## Issues found with 1st assembly JD

## Issues found with functional testing

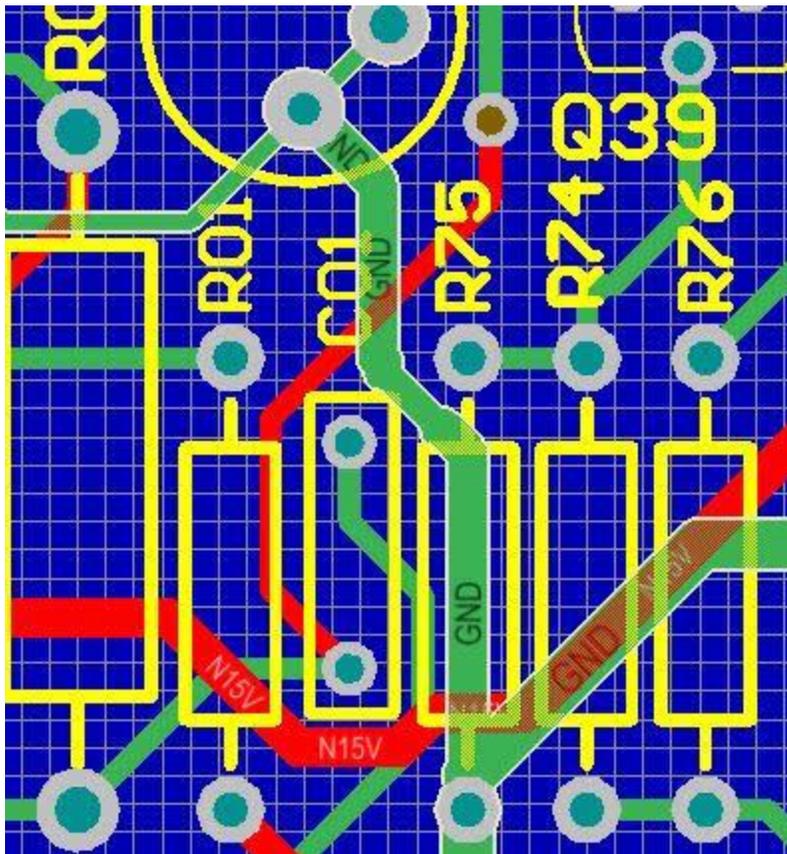
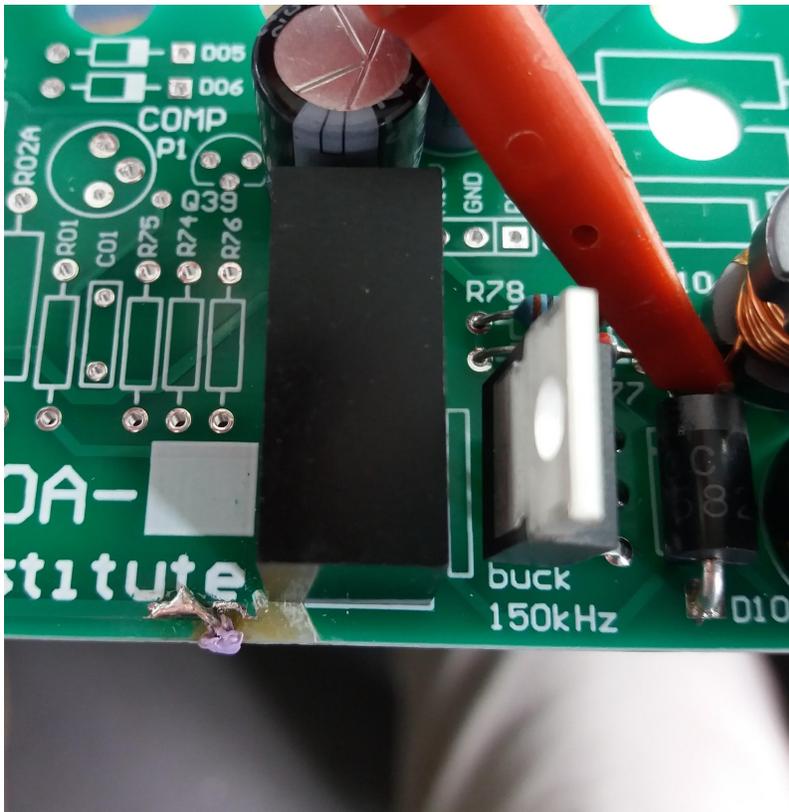
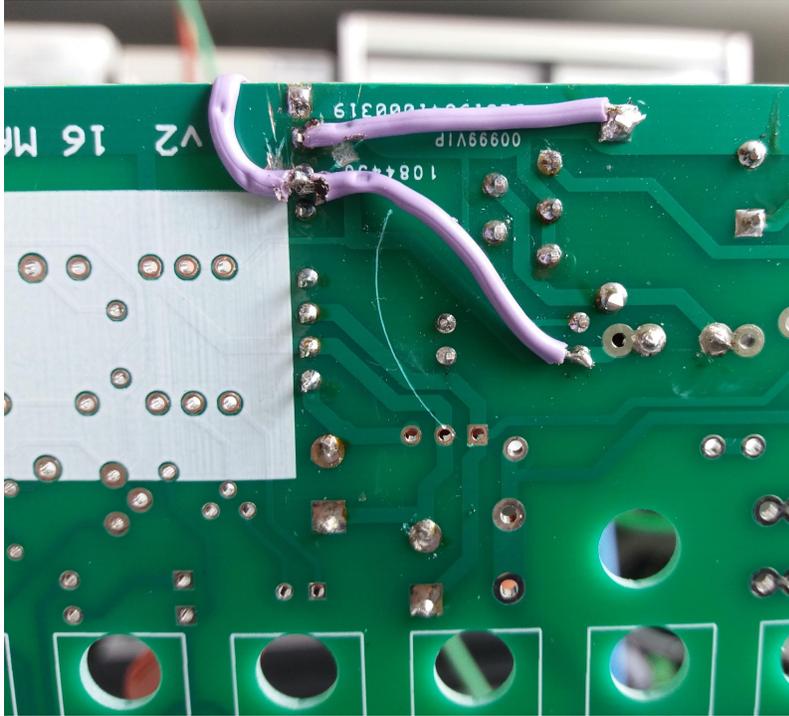
pole, given the 7 to 10 MHz bandwidth I was seeking. I don't recall experimenting much with that value, larger may be better. Also, if you aim for a little lower  $f_{-3dB}$ , you'll want a larger C01 value.

Here's the layout for C01. You can see there's a via between the trimpot and Q39. You can cut the continuing trace under, and add a wire from the via, over to Q25. But, it'd be convenient to do this before mounting the surrounding parts. If you want to experiment, you can always move the far end of the wire later (that end of the cap is at low-Z, without sensitive wiring issues). And C01 is well exposed, so you can play with its value. Tacking an extra cap to the pins underneath may be a good way to experiment, or you may want to stand up the part a bit so you can snip wires and solder parts on top. Yessir, I'm sure y'all have experience doing things like that.

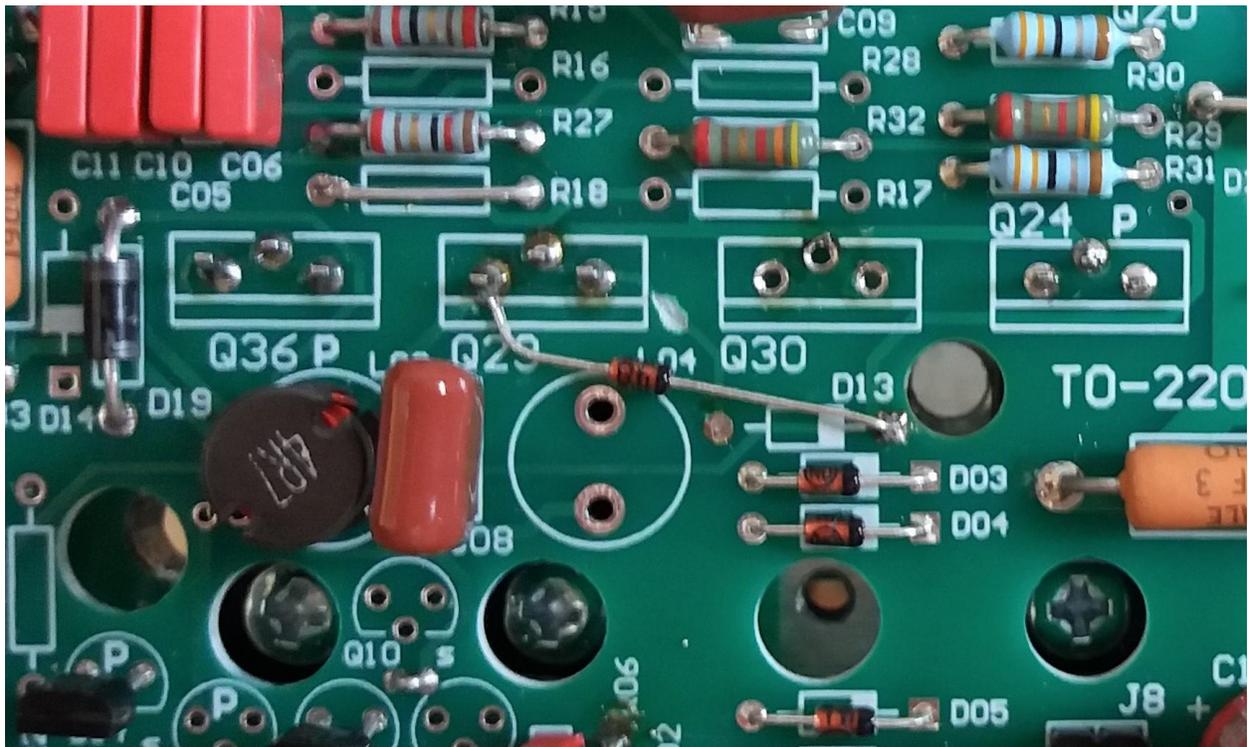
1. Space between PM3, PM3 and electrolytics C26, C27 is tight. Use smallest diameter electrolytic available.
2. There is a difference in connection between clamp diodes D12 and D13. D12 runs from Vc to **EQ15**, while D13 runs from **BQ29** to Ve. It appears that the D12 connection is correct. The D13 connection to **BQ29** should be changed to **EQ29**.
3. Did the modification: cut the trace on the top between BQ29 and Anode-D13. Then mount new D13 between original pad for Cathode-D13 and EQ29. See picture below. Functional test OK.

Q15 base stopper

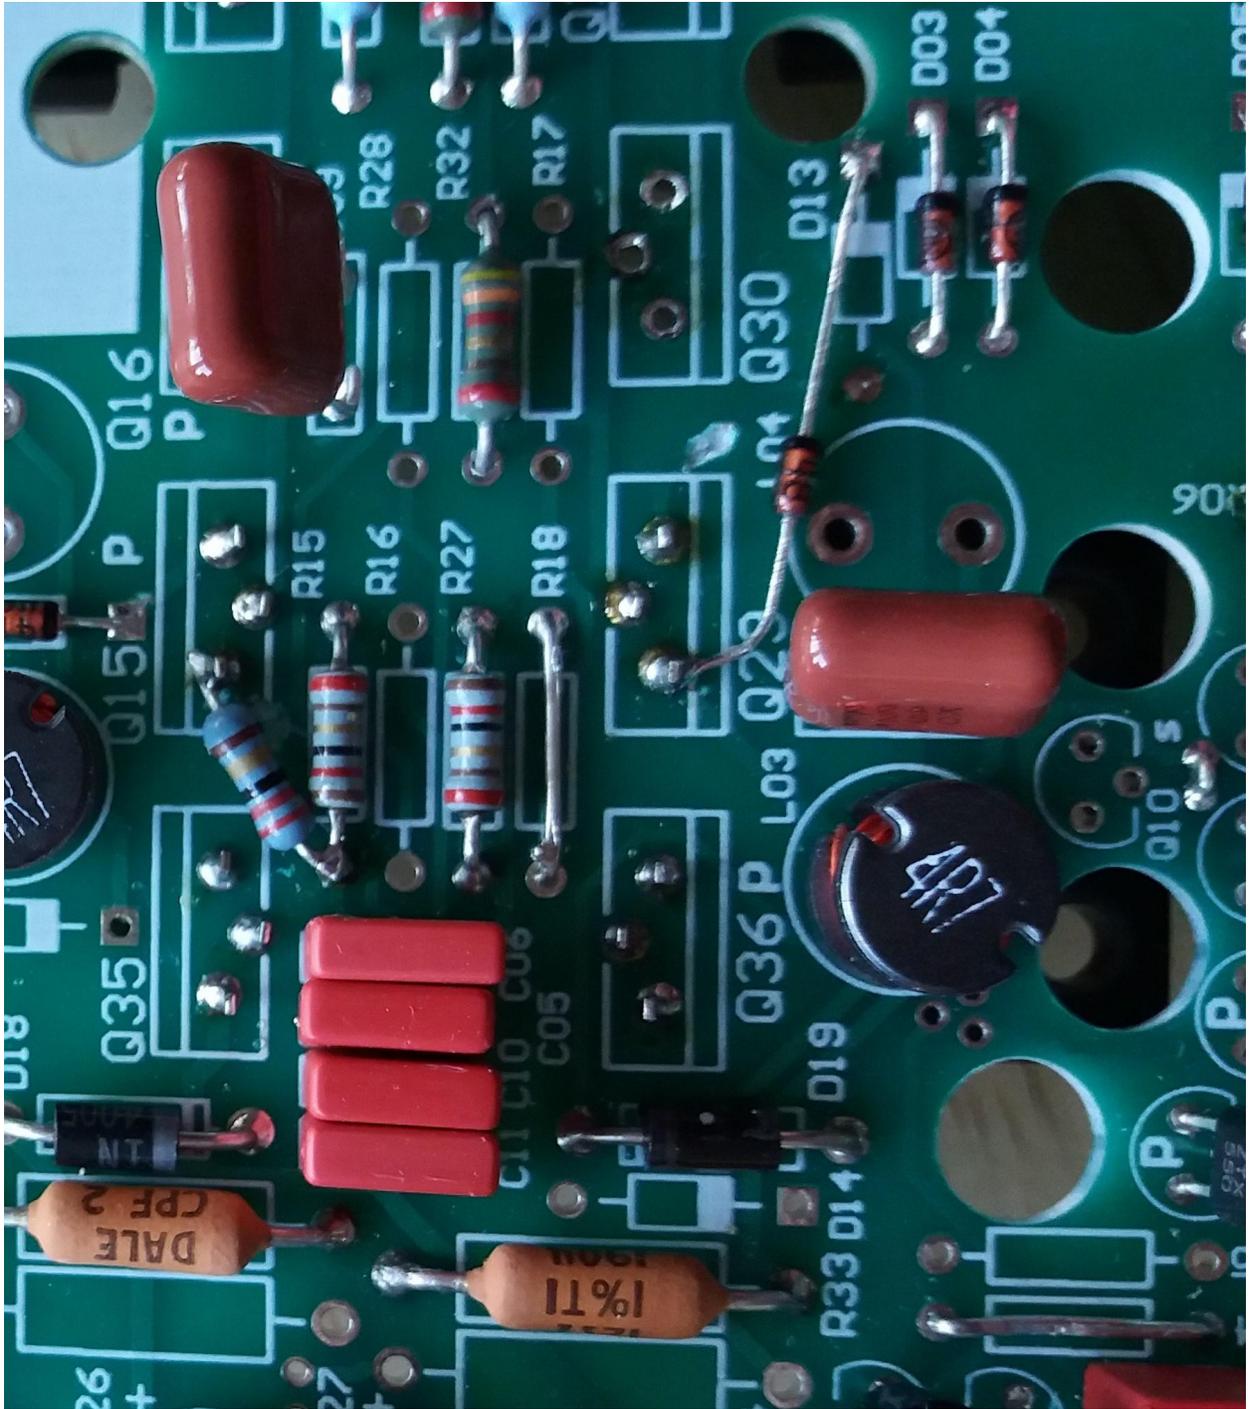
5. The 2nd oscillation which looked more like 'squegging' was not influenced by P1. Reviewing the construction and test report from the German Tigris group revealed that they had similar issues. This was solved by inserting a  $22\Omega$  base stopper resistor directly at the base of Q15 and Q29. This completely cured all oscillations. See pictures below. The reasoning was that this stopped HF feedback through the supply lines through C05 and C10.
